# **Groundwater Application Review Summary Form**

### WATER RESOURCES DEPARTMENT **MEMO** Application G-18776 TO: GW: Wood (Reviewer's Name) FROM: **SUBJECT: Scenic Waterway Interference Evaluation** YES The source of appropriation is within or above a Scenic Waterway NO YES Use the Scenic Waterway condition (Condition 7J) A NO Per ORS 390.835, the Groundwater Section is able to calculate ground water interference with surface water that contributes to a Scenic Waterway. The calculated interference is distributed below. Per ORS 390.835, the Groundwater Section is unable to calculate ground water interference with surface water that contributes to a scenic waterway; therefore, the Department is unable to find that there is a preponderance of evidence that the proposed use will measurably reduce the surface water flows necessary to maintain the free-flowing character of a scenic waterway. DISTRIBUTION OF INTERFERENCE Calculate the percentage of consumptive use by month and fill in the table below. If interference cannot be calculated, per criteria in 390.835, do not fill in the table but check the "unable" option above, thus informing Water Rights that the Department is unable to ma

Figure 3. Water-Level Trends in Nearby Wells. There are no recent time-series data available.

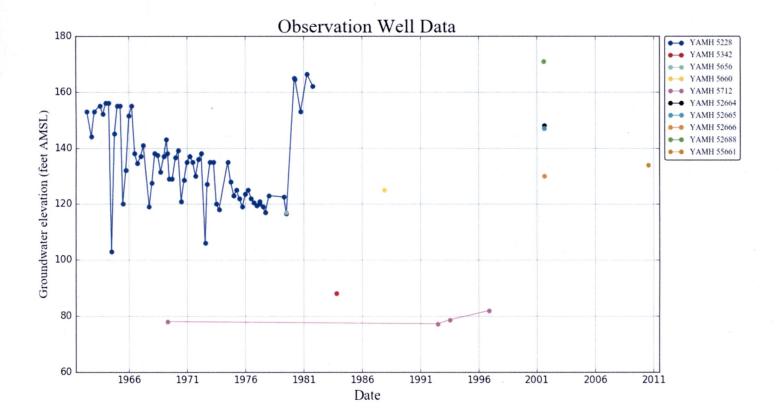
a.	Condition to allow groundwater production from no deeper than ft. below land surface;
b.	Condition to allow groundwater production from no shallower than ft. below land surface;
	Condition to allow groundwater production only from the groundwater reservoir between approximately ft. and ft. below land surface;
	to occur with this use and without reconstructing are cited below. Without reconstruction, I recommend withholding issuance of the permit until evidence of well reconstruction is filed with the Department and approved by the Groundwater Section.  Describe injury —as related to water availability— that is likely to occur without well reconstruction (interference w/ senior water rights, not within the capacity of the resource, etc):
Silt sect The	bundwater availability remarks: The proposed wells will produce water from sand, gravel and clay of the Willamette and underlain, the aquifer is 20 to 40 feet thick; it is overlain by approximately 80 feet of fine-grained Willamette and underlain by about 1600 feet of the predominantly fine-grained Willamette confining unit. A survey of well logs in ions 11 &12 found 65 well logs on record. Yields range from 2 to 327 gpm with a median yield of 30 gpm.  The proposed wells within a mile of the proposed wells. Therefore, the groundwater cannot be remined to be over appropriated. Because there is a lack of recent, nearby water level data, water level use and water level intoring conditions are recommended.

Figure 4. Stream Depletion

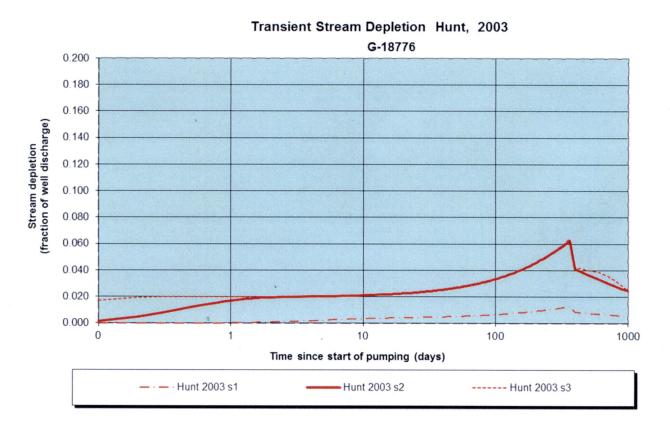
Comments: Per 690-09-040, PSI is triggered because the wells are hydraulically connected to nearby creeks within one mile
and the proposed rate is greater than 1% of relevant instream rights and 1% of the 80% exceedance flows within the water
availability basin. Stream depletion is much less than 25% at 30 days when modelled with Hunt, 2003 (see Figure 4).
·
